CITY OF WESTWOOD, KANSAS

PLANNING COMMISSION MEETING

Staff Report

WE-2024-04 – Application of homeowner Joseph Hirleman for a waiver/exception from Westwood Zoning Ordinance Article No. 4.3.2(D) to allow a primary structure to have less than 60% of its front façade on the front build-to line for a proposed new single-family residence on property located at 4831 Booth St., Westwood, Kansas 66205.

S-0.3

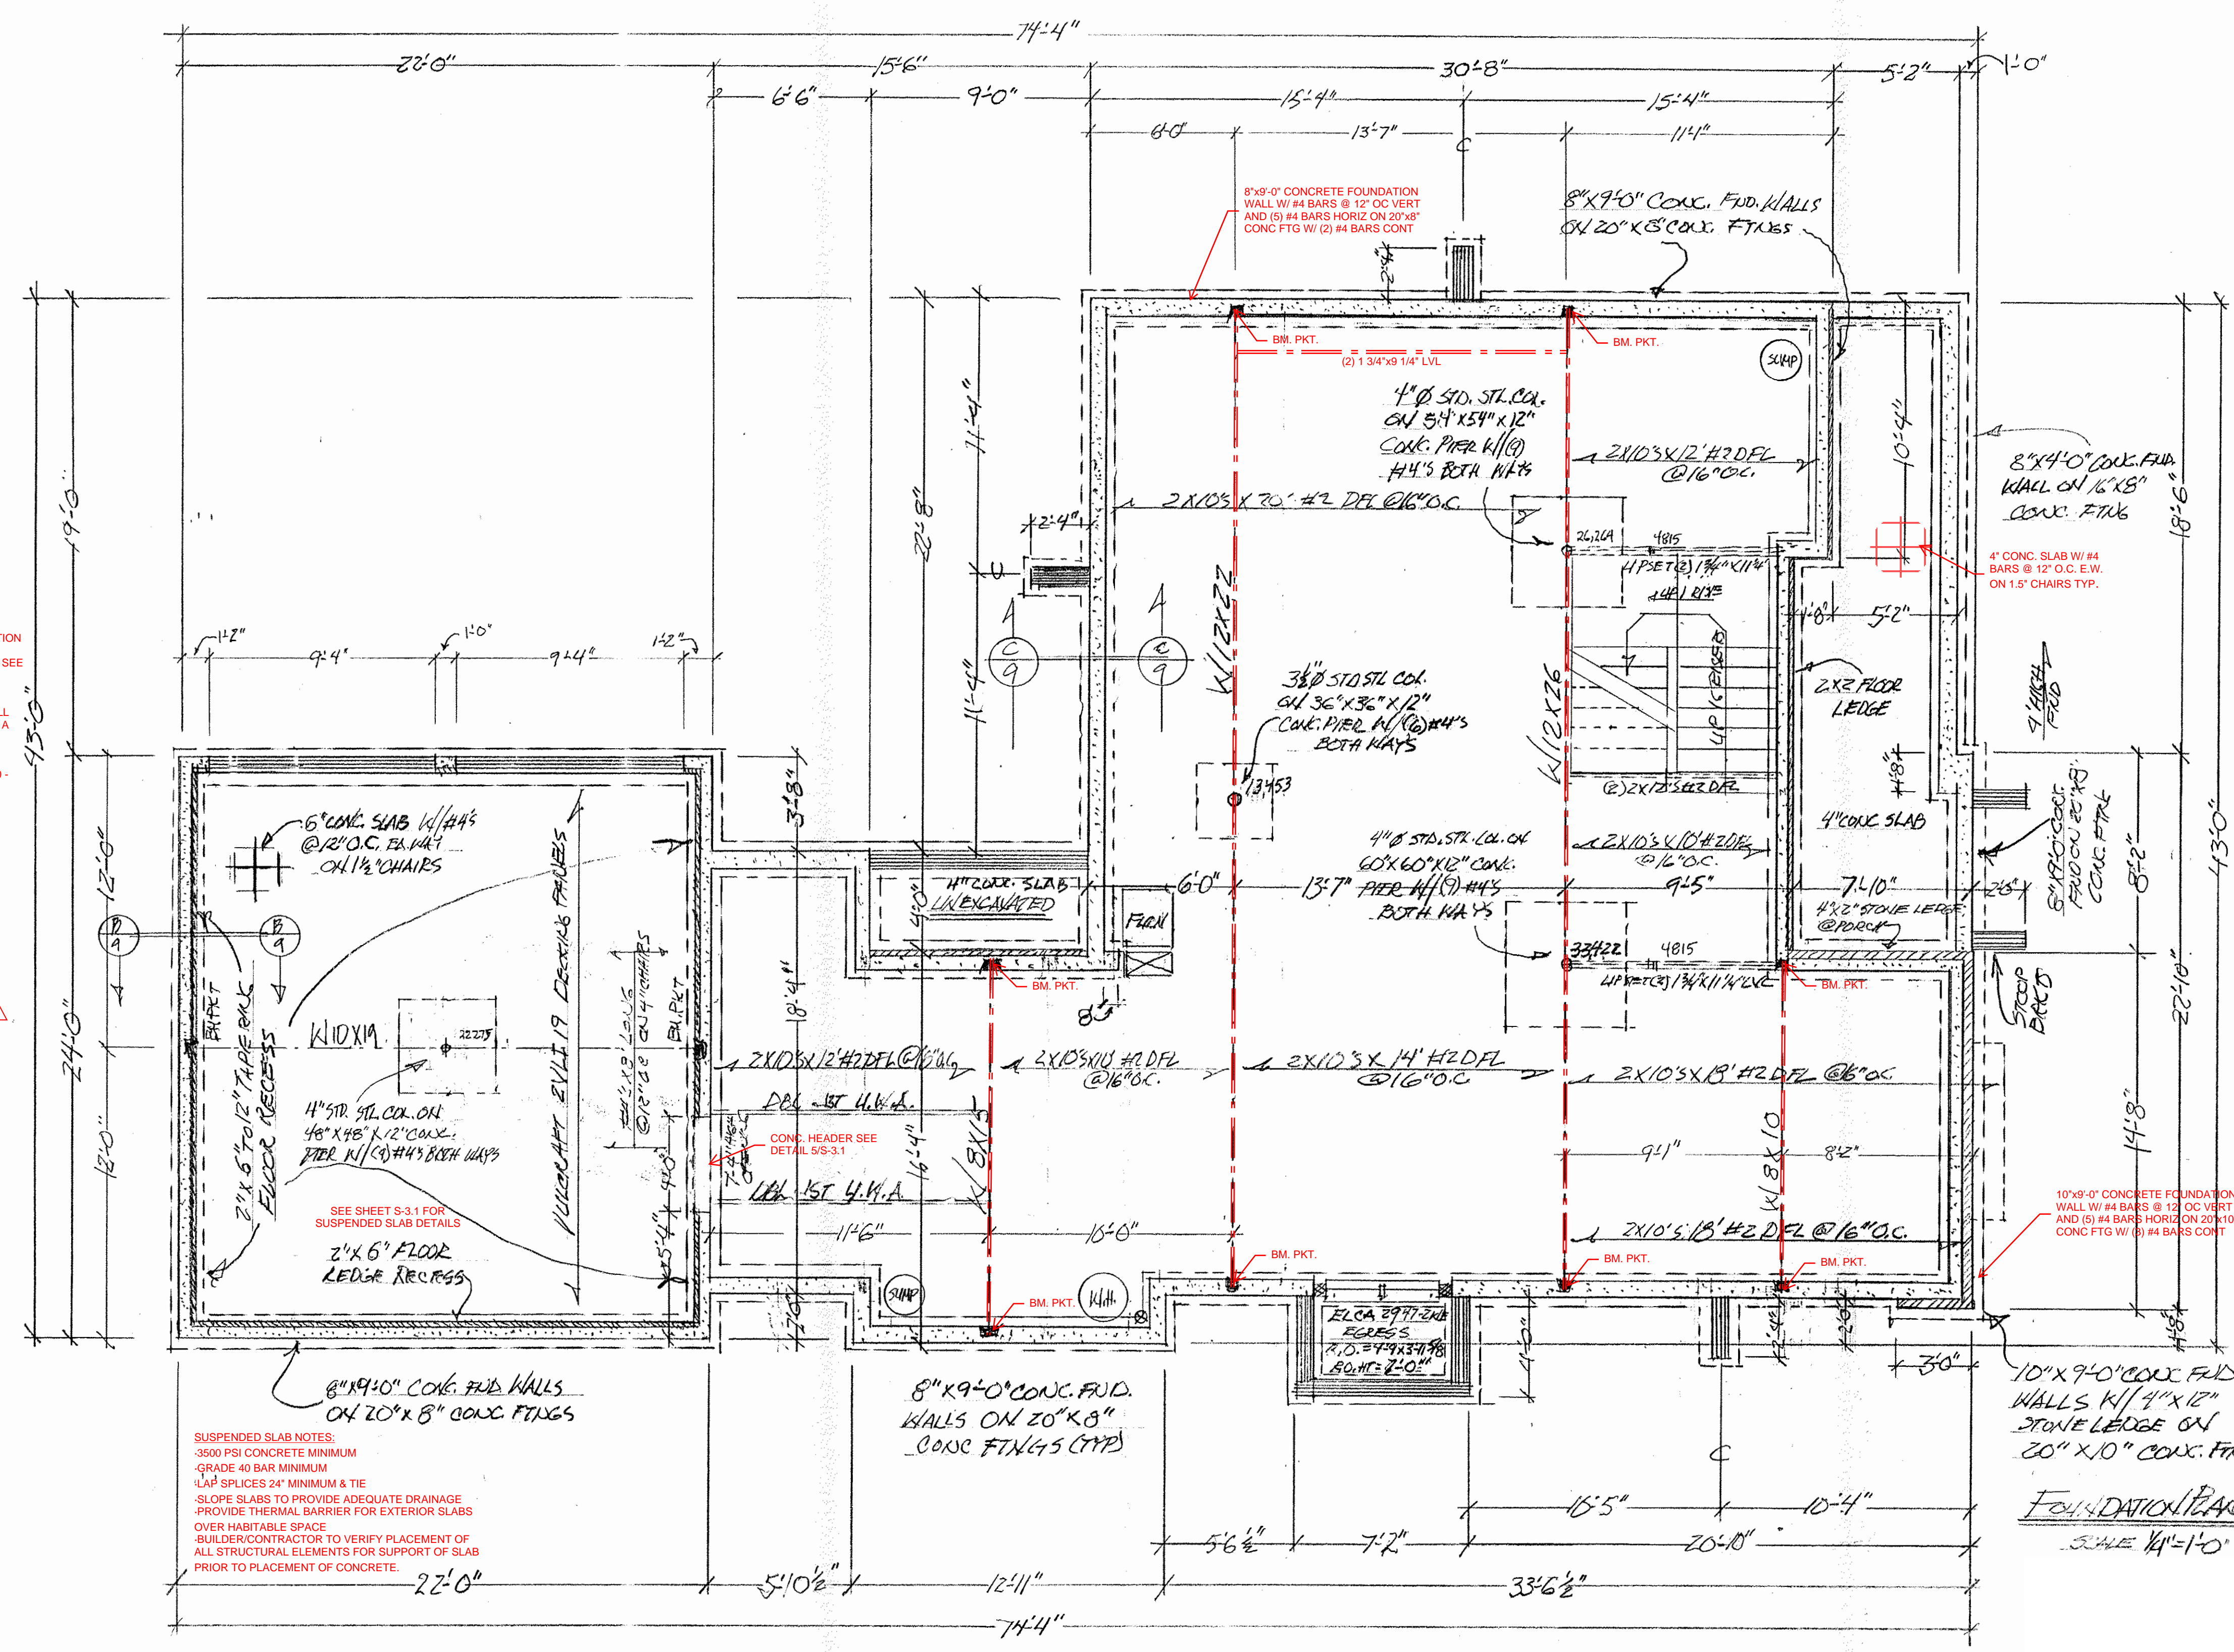
1. Confirm/update plans to reference ASCE 7-16.
This note has been changed from 7-10 to 7-16. See clouded plan changes.
2. Include prescriptive design for braced wall lines and show locations of braced wall design on plans per IRC R106.1.3 Include end conditions for constantly sheathed walls.
As noted and detailed on the plans, we are not using prescriptive bracing we are using the alternative that corresponds with the notes, details, and calculations provided on the plans.
3. Clarify foundation drainage plan.
Any required drainage plans shall be provided by civil engineer.
4. Update S-4.0 to match adopted amended energy requirements per Westwood Municipal Code.
See attached clouded plan update.

BRACED WALLS:
 SEE CALCULATIONS ON SHEET S-2.0, PER ASCE7-16 REQUIREMENTS AS ALLOWED BY IRC 2018 R301.2.1
 ALL EXTERIOR WALLS SHALL BE SHEATHED PER ANY ONE OF THE FOLLOWING OPTIONS:
 - 7/16" APA-RATED PLYWOOD/OSB WITH 8d NAILS @ 6" O.C. AT EDGES AND @ 12" O.C. IN THE FIELD
 - 7/16" SHIPLAP PANEL SHEATHING (I.E. LP SMARTSIDE OR EQUIVALENT) WITH 8d NAILS @ 6" O.C. AT EDGES AND @ 12" O.C. IN THE FIELD
 - 3/8" SHIPLAP PANEL SHEATHING (I.E. LP SMARTSIDE OR EQUIVALENT) WITH 6d NAILS @ 4" O.C. AT EDGES AND @ 12" O.C. IN THE FIELD
 INTERIOR BRACED WALL LOCATIONS ONLY SHOWN WHEN REQUIRED BY ADDITIONAL BRACING SECTION OF CALCULATIONS ON SHEET S-2.0
